EVANS  
TAYLOR  
FOSTER  
CHILDRESS  
ARCHITECTS  
343 North Main Street  
Memphis TN 38103

**ADDENDUM NO. 3**  
**March 8, 2024**

**FIRE STATION # 1**  
**City of Marion**  
**Marion, AR 72364**

P3.1

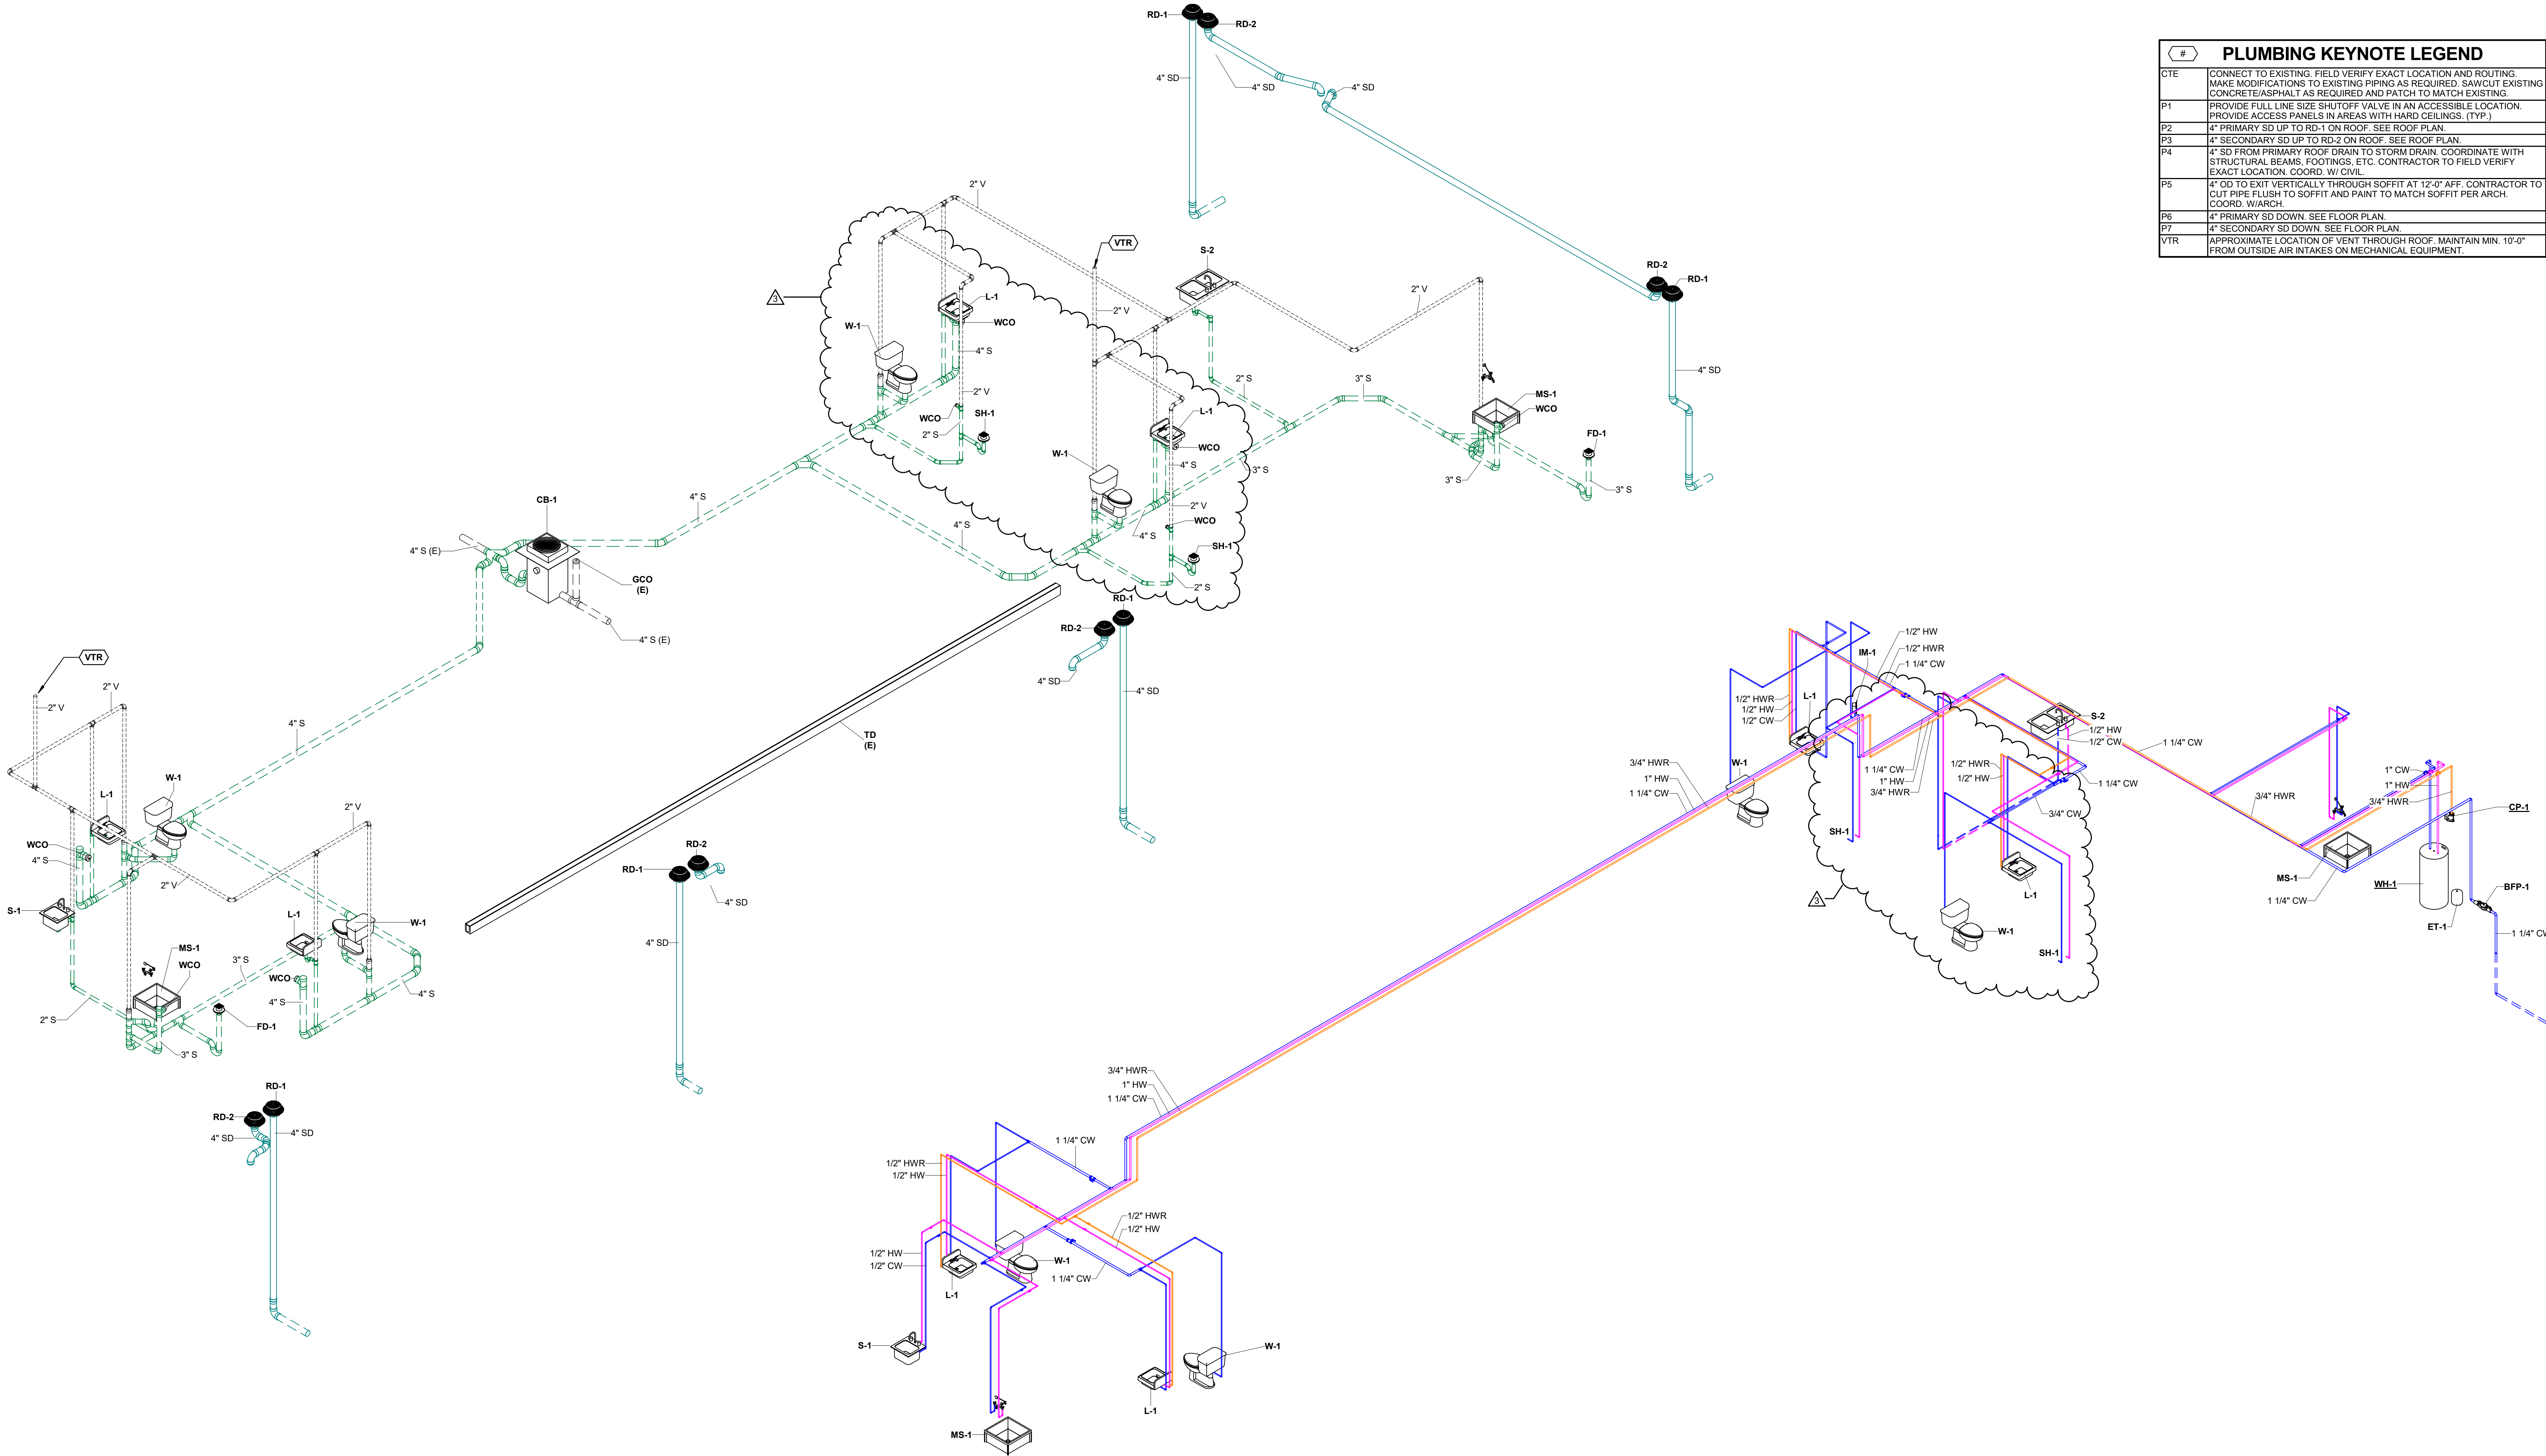
P3.1 Added plumbing to showers at [119] Storm Shelter and [120] Restroom 3.

ELECTRICAL DETAILS  
Drawing Number:  
**E3.1**  
Date: September 29, 2023  
Project Number: 22207

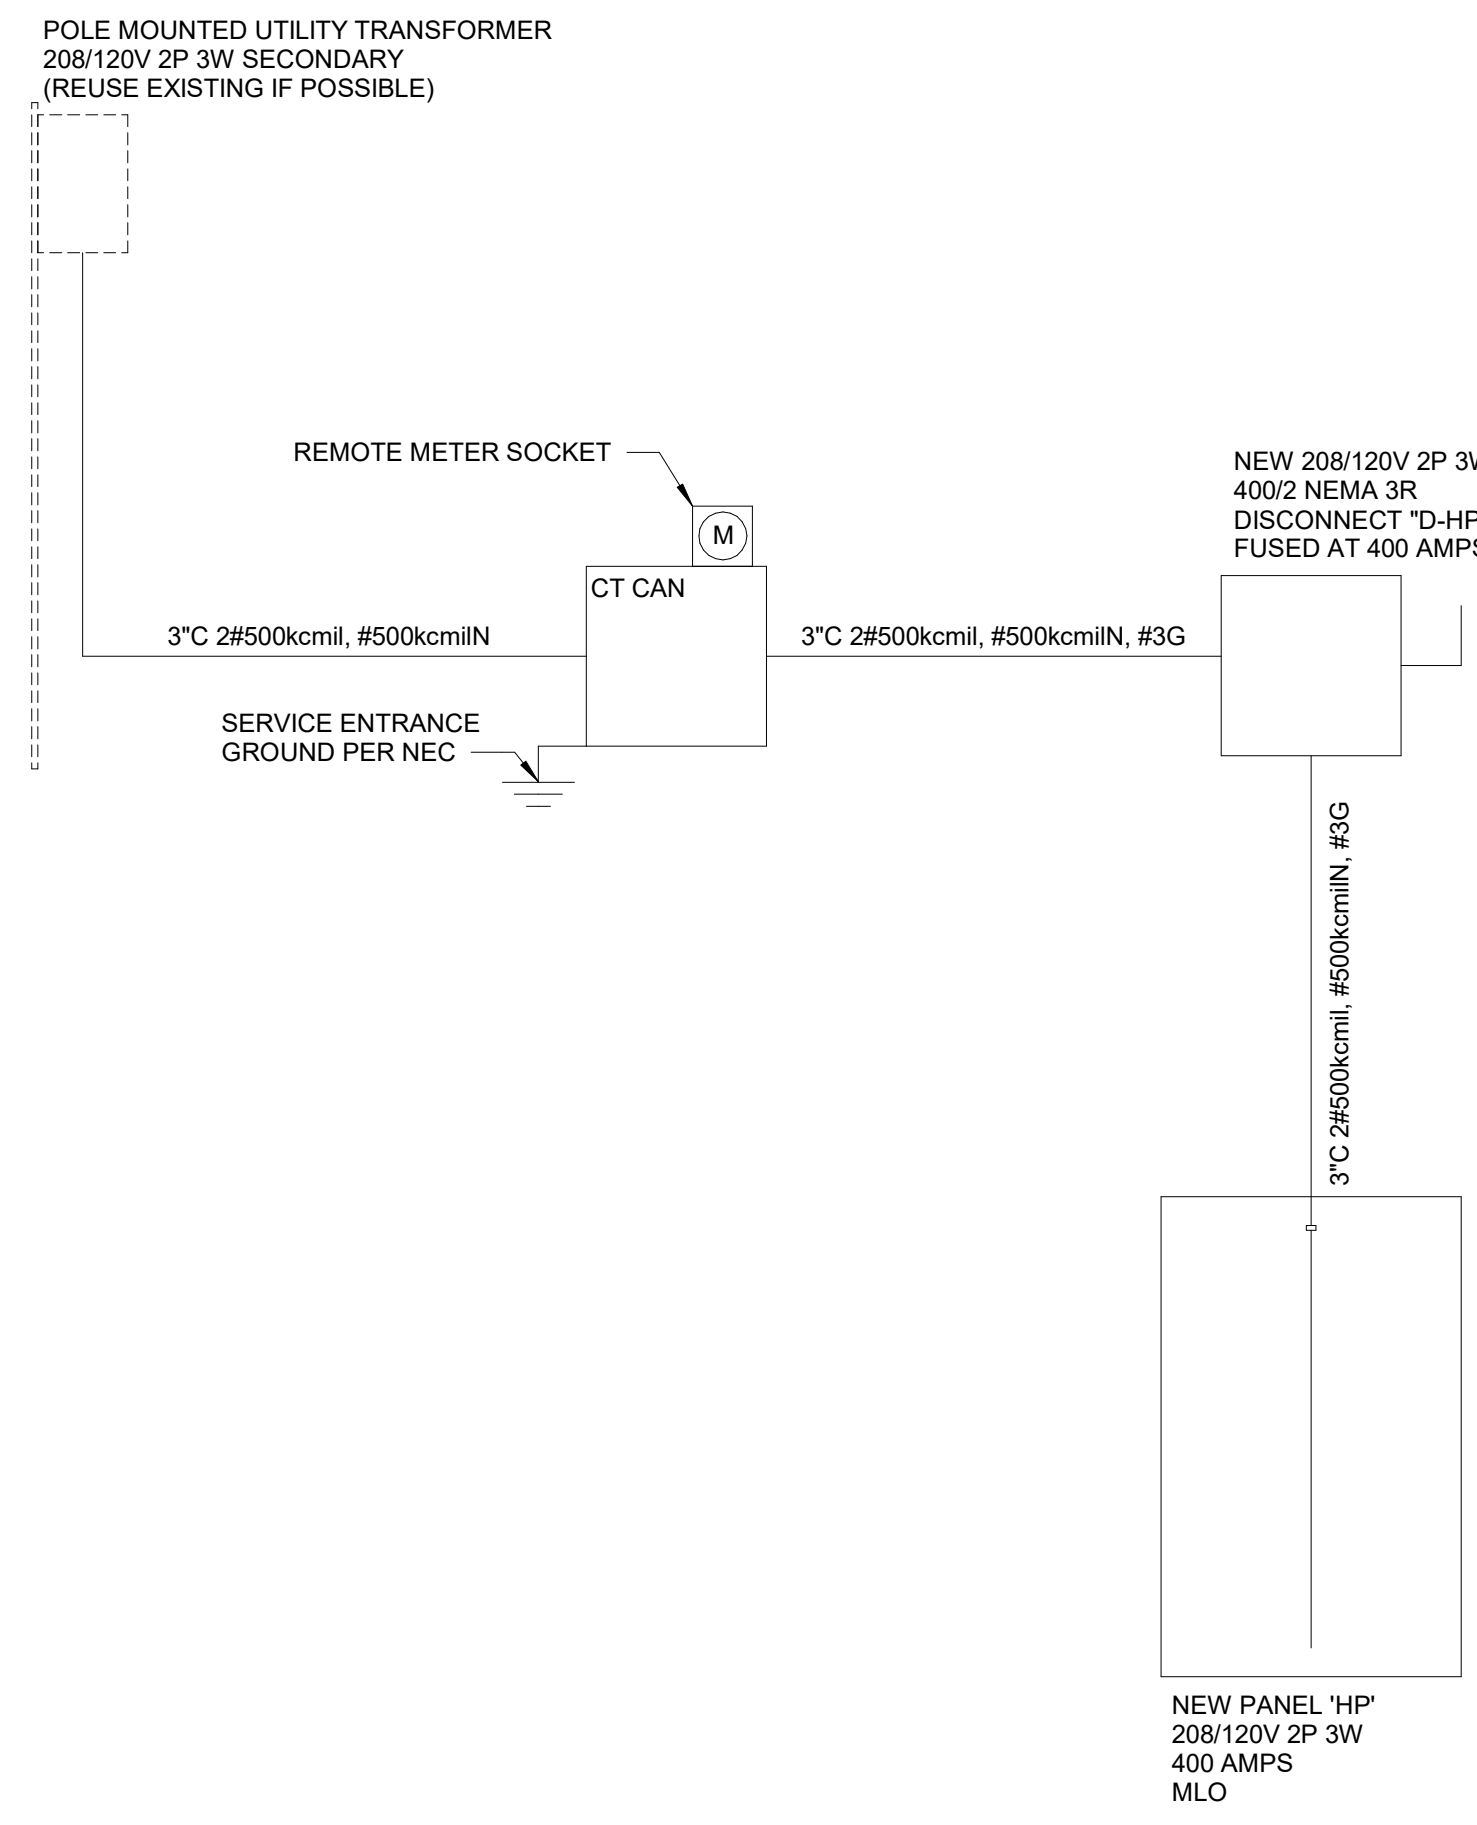
E3.1 Revised Branch Panel layout at Overhead Doors.
